**FINAL
MITIGATION PLAN**

**MARINE BENTHIC RESOURCE SURVEY
FORT SAN GERONIMO
SAN JUAN, PUERTO RICO**

**CONTRACT NUMBER: W912EP-08-D-0004
TASK ORDER NUMBER: 0013**

Image 16. Approximate location of the proposed coral recipient site MAKE SURE MAP PRINTS RECIPIENT SITE

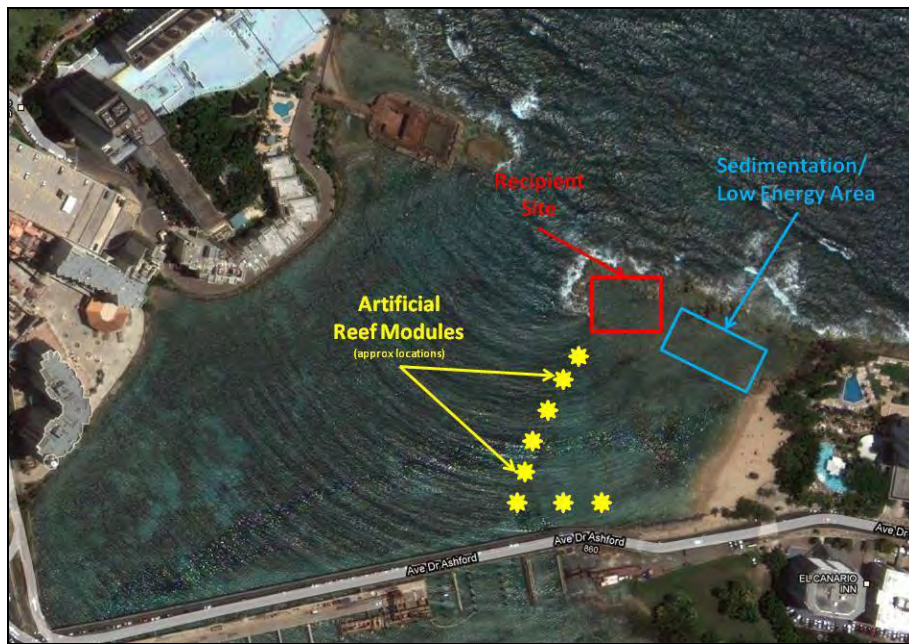
2. should have permanent markers at transplant locations in addition to mapping the location of transplanted colonies so that these colonies can be easily identified for future monitoring. In addition, the plan should specify that photos will be taken at the same height, angle, etc. relative to the colonies to be sure photos are comparable over time.

- 1) While the mitigation plan currently mentions that some rocks with attached corals will be moved to the mitigation site, it also states that some larger rocks will not. Unless there is some structural reason for not relocating a certain rock, size of the rocks should not be a limiting factor. Larger rocks may be more stable in the relocations site. Lift bags, other flotation devices, or even small cranes on a barge can be used to maneuver the rocks into a new location.
- 2) The relocation site may be more exposed to wave action than the current Fort San Geronimo site. There is no mention of the need or methods to stabilize the transplanted rocks. The relocation of individual corals does not specify where

they will be reattached; it is not clear if existing substrate in the relocation area will be used or if relocated rocks will provide the substrate.
